Final Bridge and Channel Design Report

Sand Creek Drainageway
Sterling Ranch Road and Briargate Parkway
Branding Iron at Sterling Ranch Filing 2
Homestead at Sterling Ranch Filing 2

CDR XX-XXX
El Paso County, Colorado

Engineering Review

**SAND CREEK DRAINAGE
 BASIN PLANNING STUDY
 PRELIMINARY DESIGN PLANS**

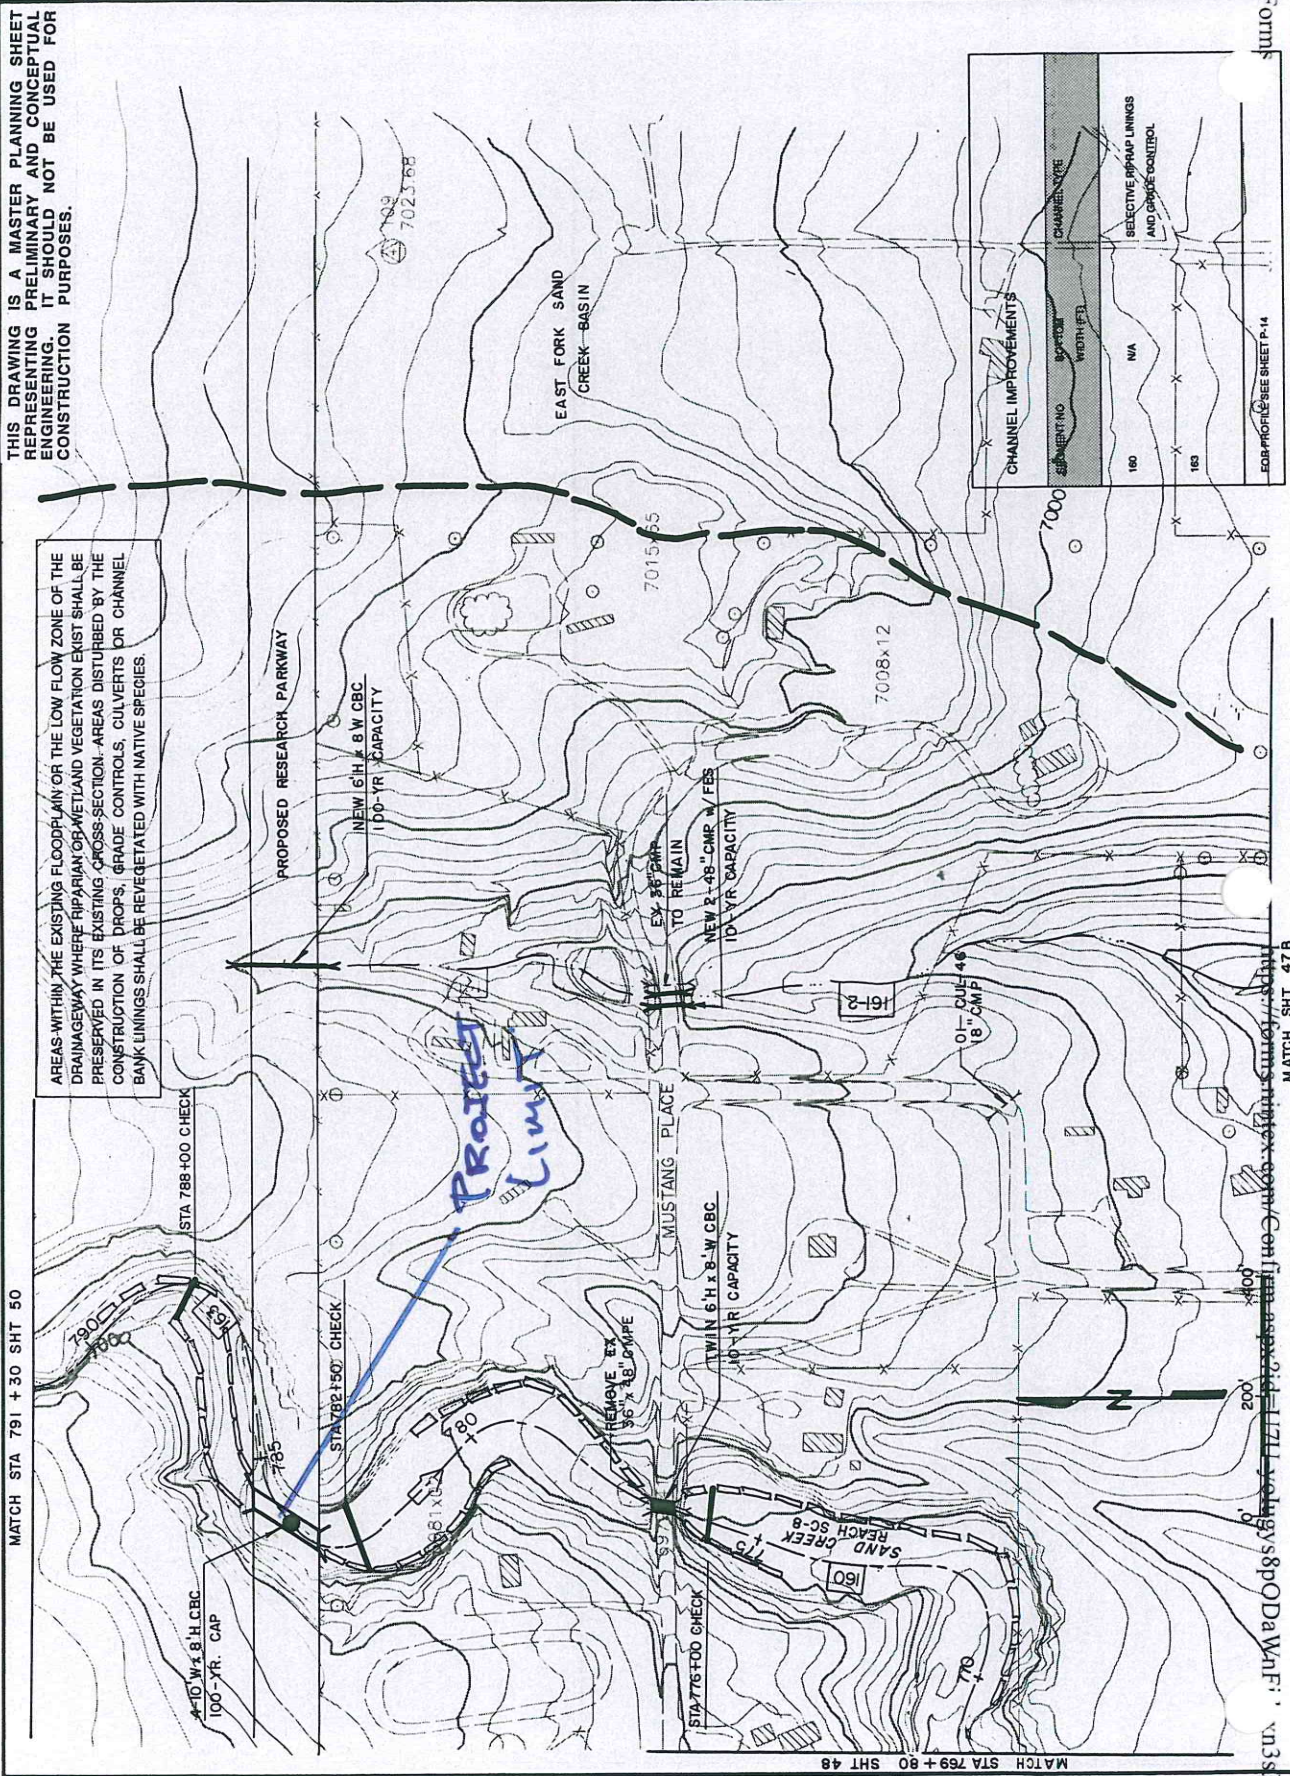
Provide Sheets 48 and 47

SITE MAP
SCALE: NTS

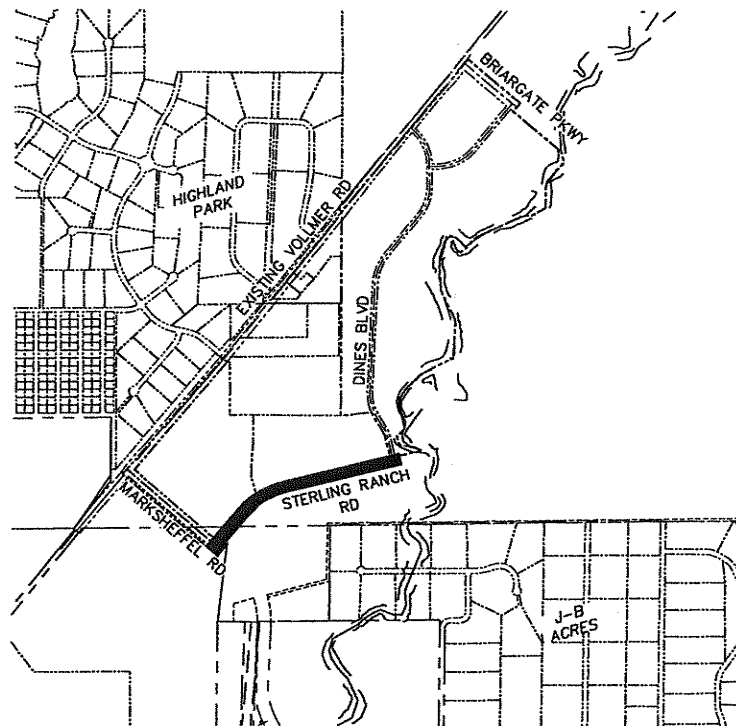
Update when available

Wetland Impact Location Map

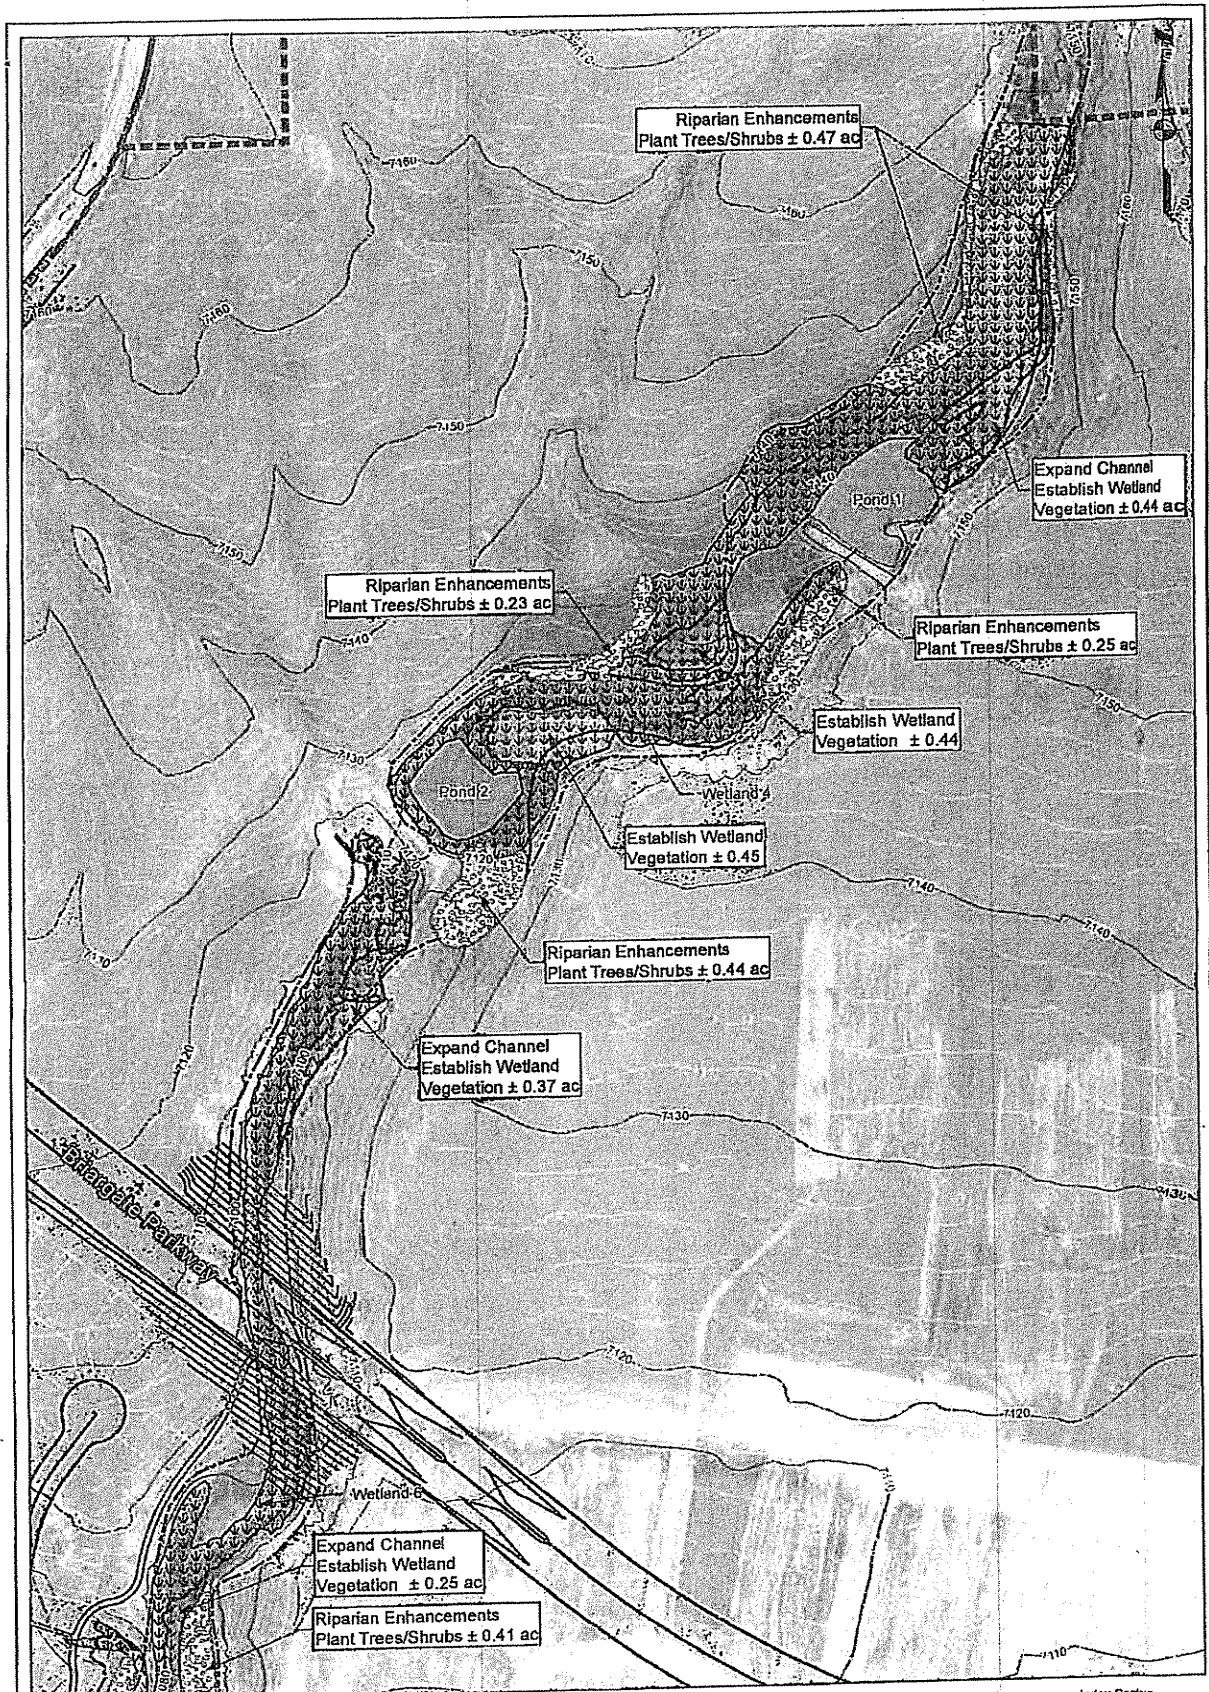
Provide original PDF versions of these Core sheets.
